ADDENDUM NO. 1

PROJECT NAME: BARBARA DRIVE DRAINAGE PROJECT (McCULLOUGH AVE TO SKIPPER DR)

DATE: 01/12/2017

TCI PROJECT NO.: 23-01398

SUBMITTAL	PROJECT NUMBER	DATE
100%	E0384400	1/12/2017
DRWN BY: EV	DSGN BY: KS	CHKD BY: MB
		SHEET NO. 8

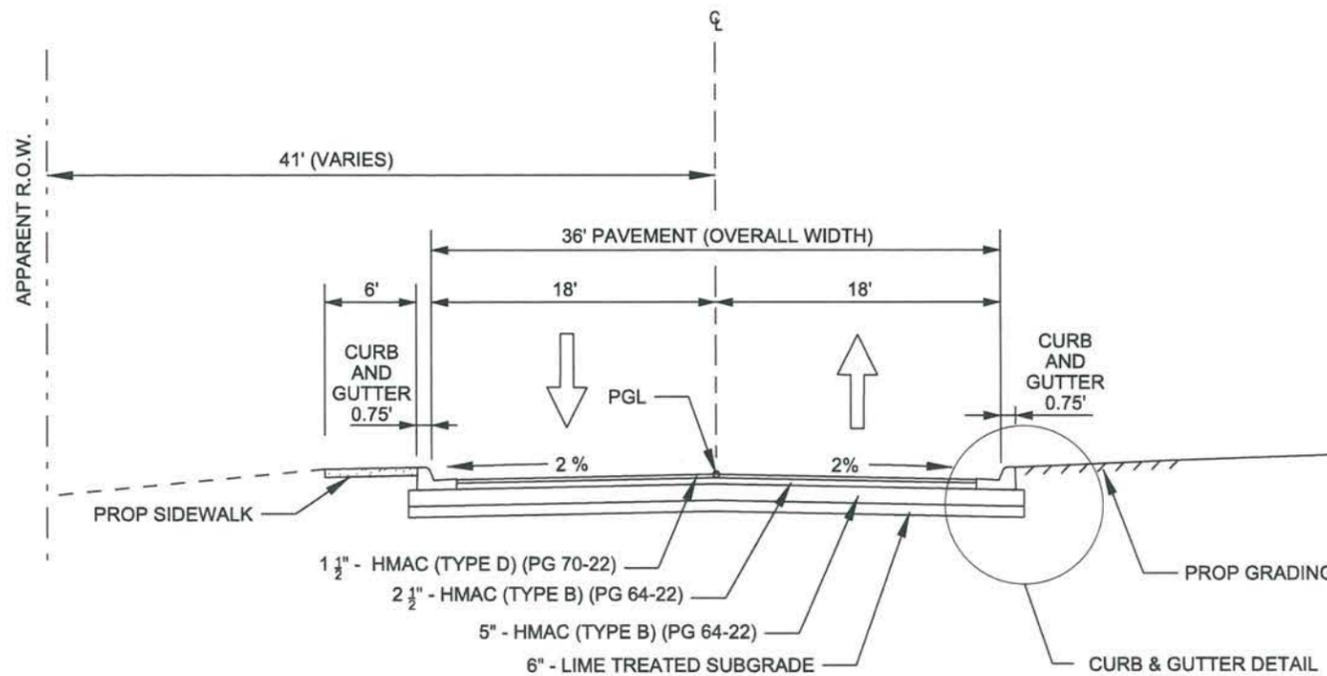
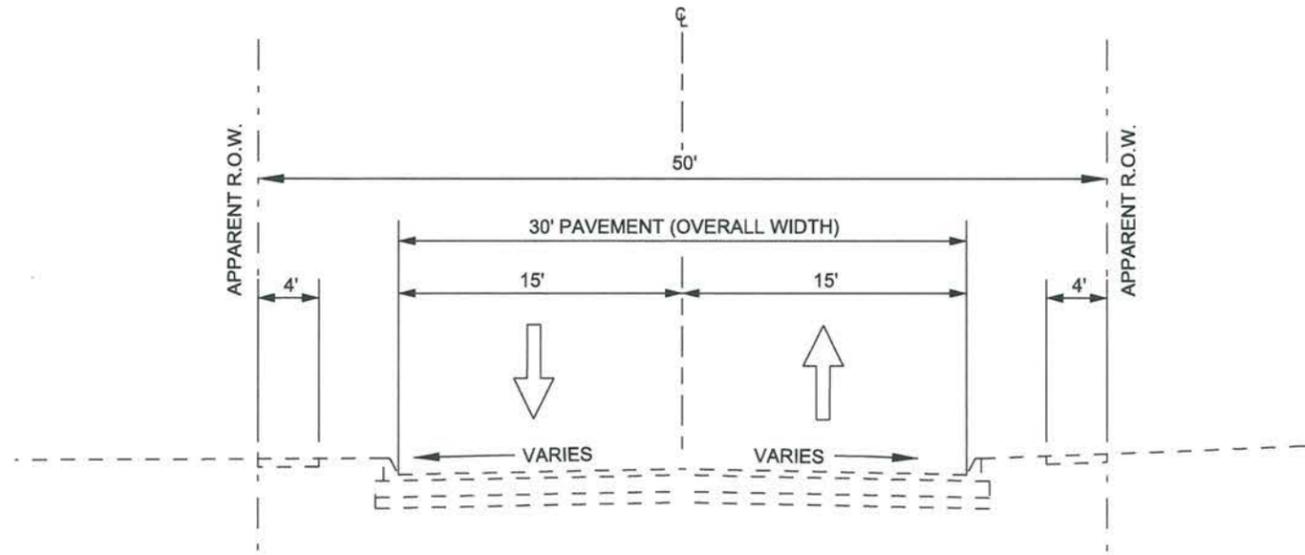
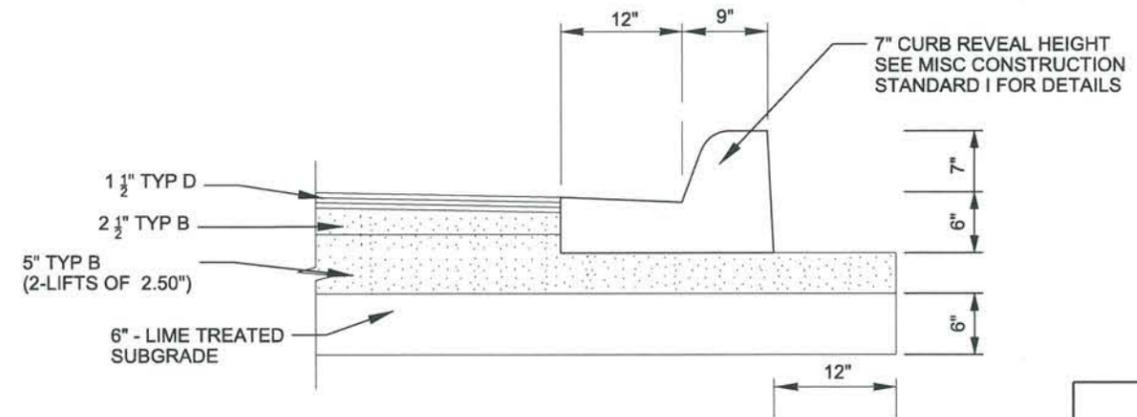
7. Substitute and utilize updated “Typical Sections” (Sheet Nos. 8 - 10) revised to clarify minimum PG Binders for asphalt.
8. Substitute and utilize “SUPPLEMENTAL GENERAL NOTES” (Sheet No. 12) revised to include detailed notes regarding Channel Excavation, Transport/Disposal of Material to a Landfill Facility (ADD. ALT. #3).

SUBMITTAL	PROJECT NUMBER	DATE
100%	E0384400	1/12/2017
DRWN BY:	DSGN BY:	CHKD BY:
EV	KS	MB
		SHEET NO.
		28

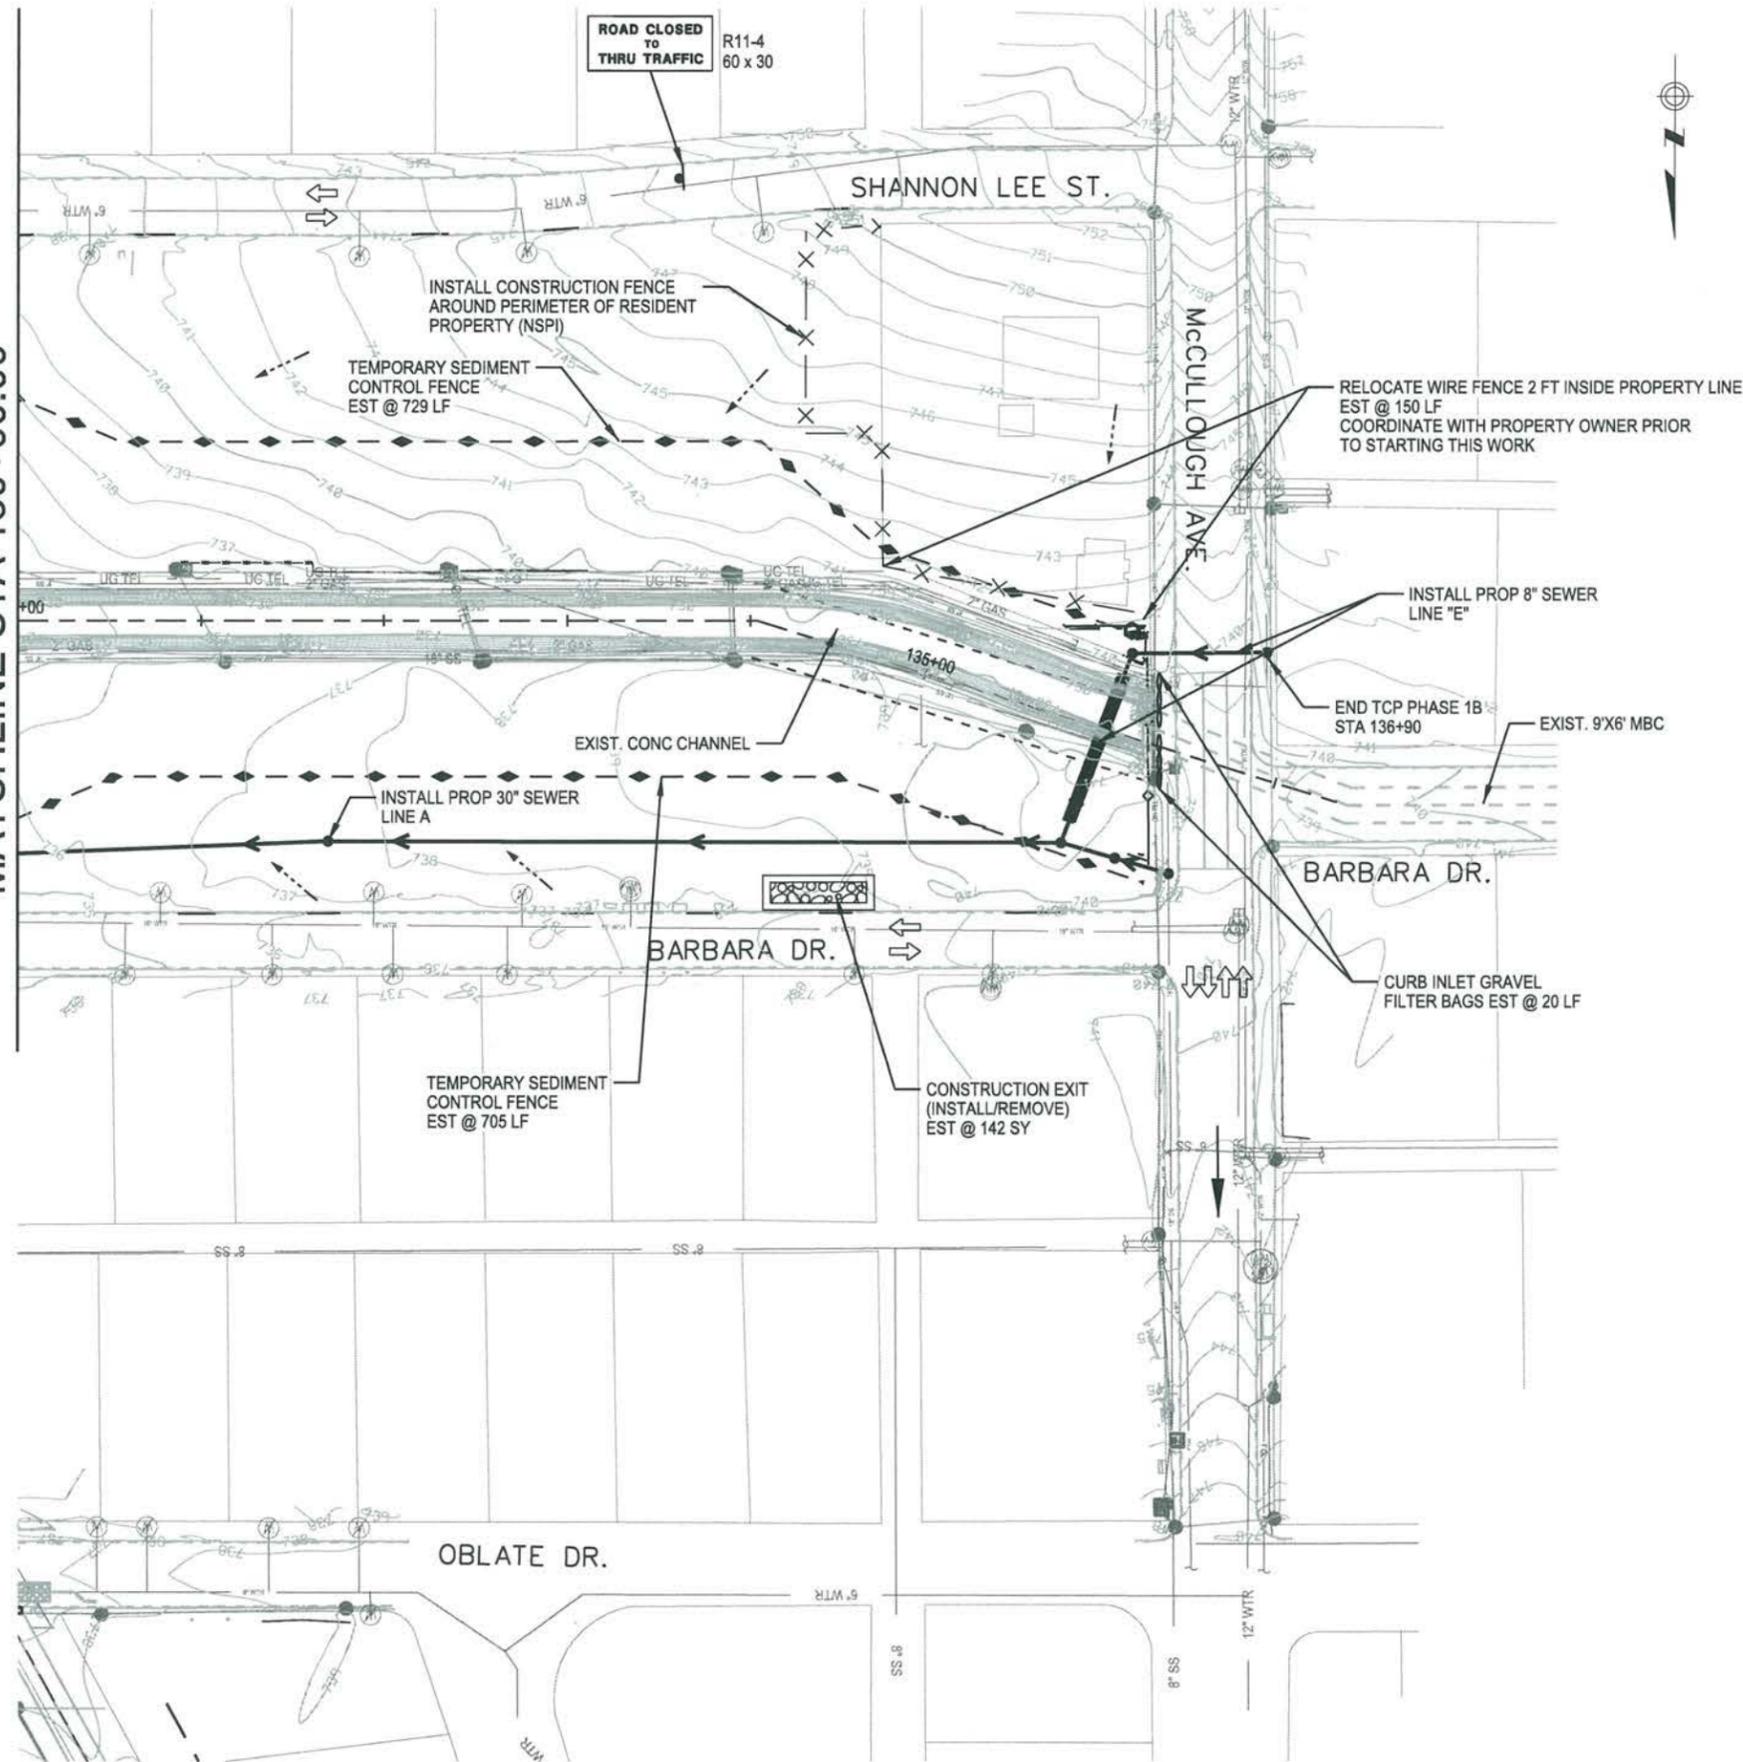
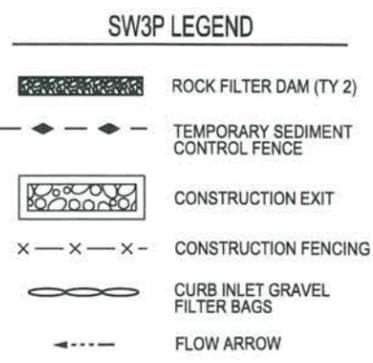
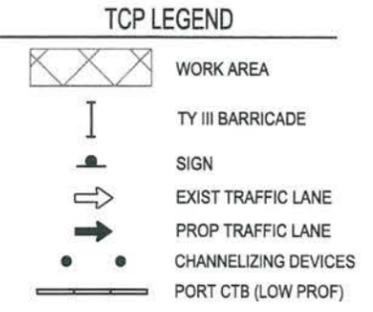
9. Substitute and utilize updated “Traffic Control & SW3P Sequence of Work” (Sheet Nos. 28 & 30) revised to clarify location of chainlink fence to be relocated and include protection requirement notes for High Water Detection System.

DRWN BY:	DSGN BY:	CHKD BY:	SHEET NO.
EV	KS	MB	53

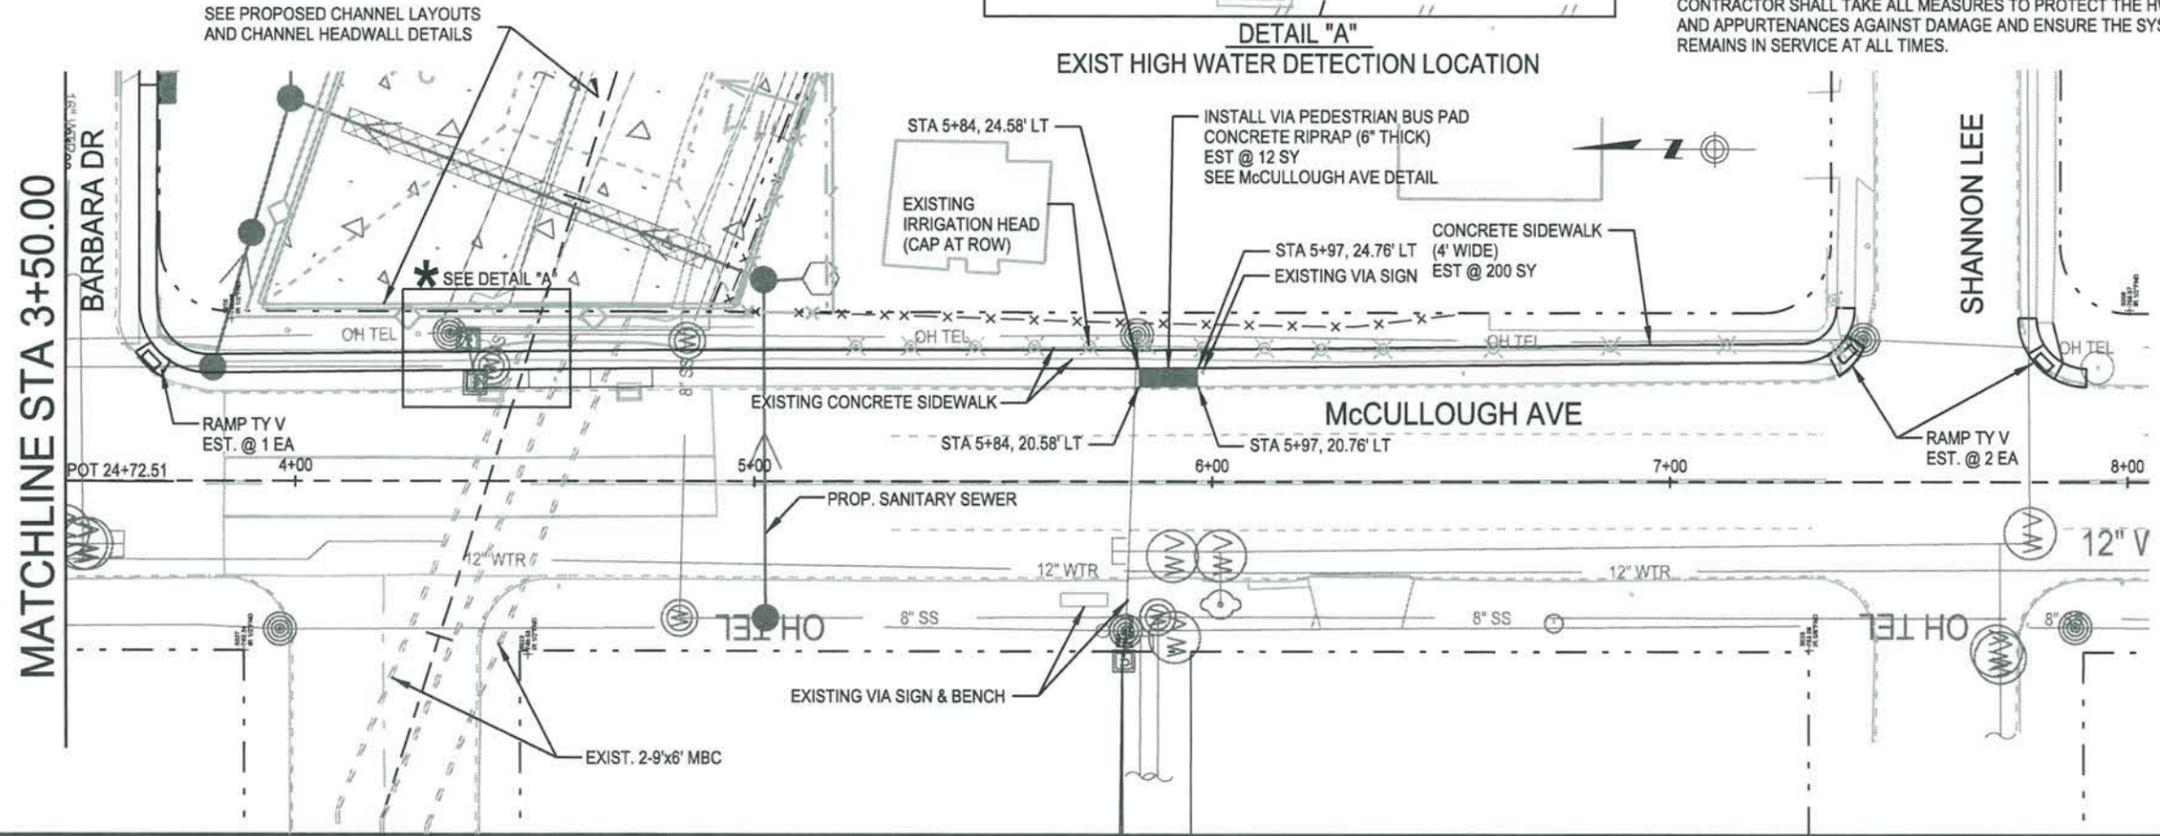
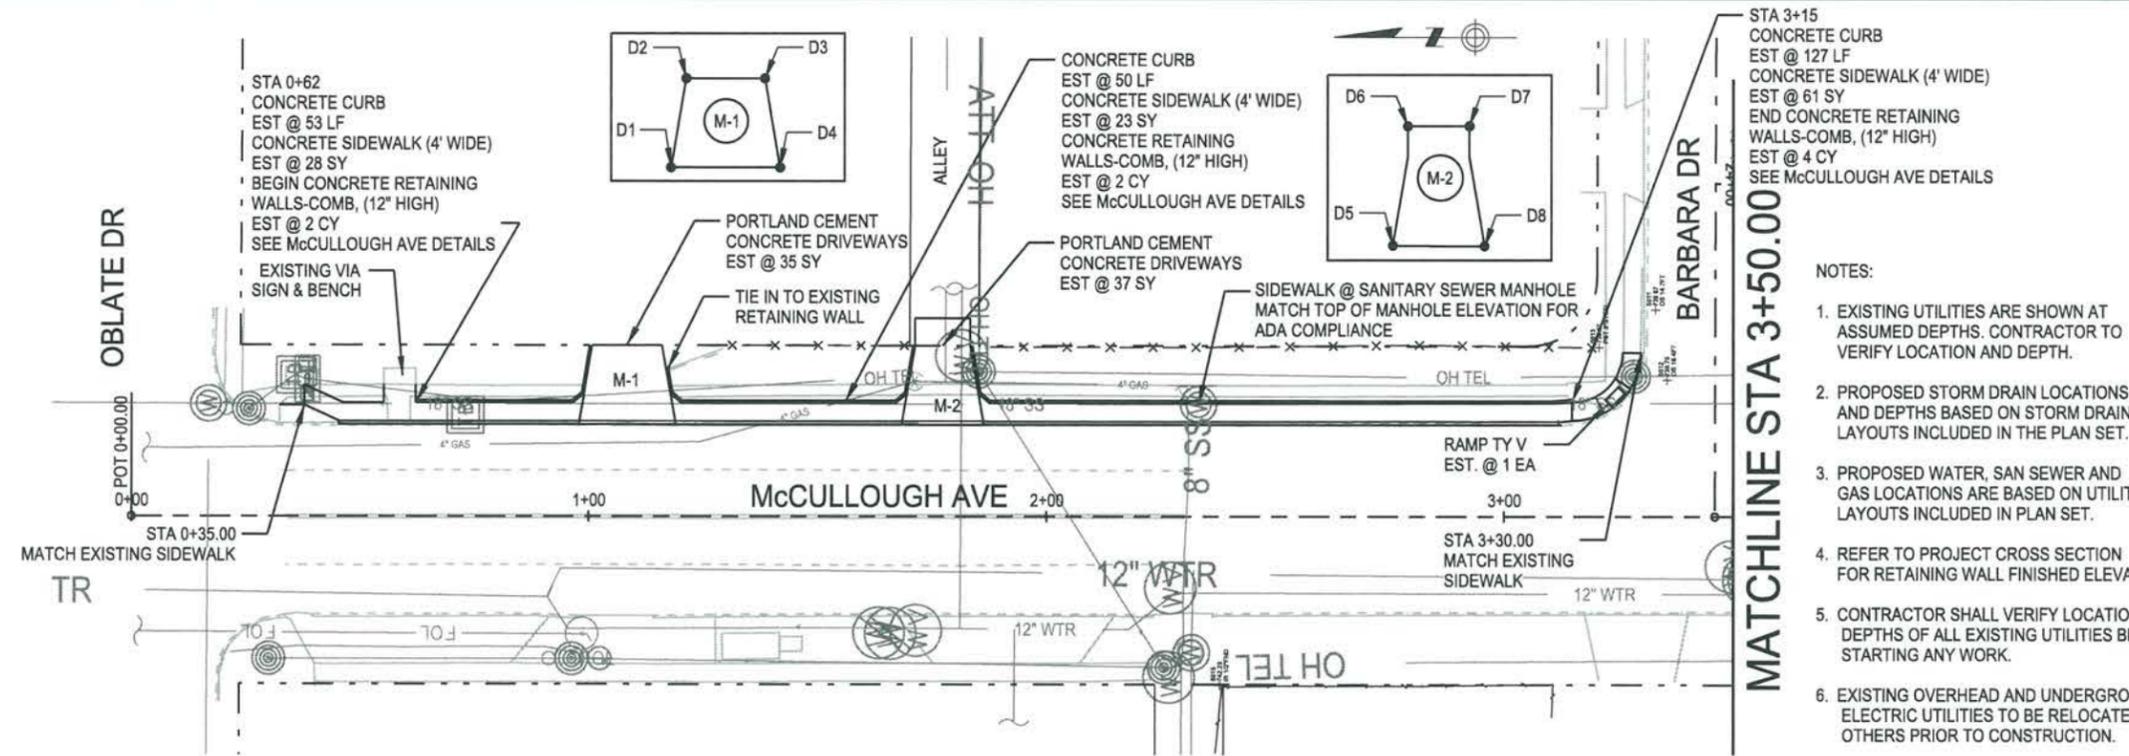
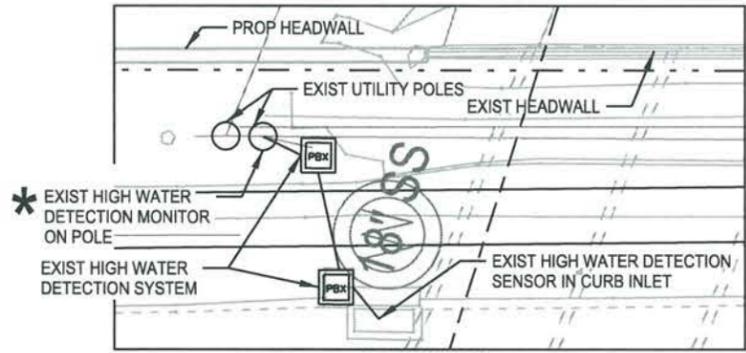
10. Substitute and utilize updated “McCullough Ave Layout” (Sheet No. 53) revised to include protection requirement notes for High Water Detection System, and capping of existing irrigation system located in the ROW.

* NOTE THAT THERE IS A HIGH WATER DETECTION SYSTEM LOCATED ADJACENT TO THE EXISTING HEADWALL AT McCULLOUGH AVENUE. THE SYSTEM IS LOCATED ON A POLE AND SHALL BE BRACED PRIOR TO BEGINNING WORK IN THIS AREA. CONTRACTOR SHALL TAKE ALL MEASURES TO PROTECT THE HWDS AND APPURTENANCES AGAINST DAMAGE AND ENSURE THE SYSTEM REMAINS IN SERVICE AT ALL TIMES.
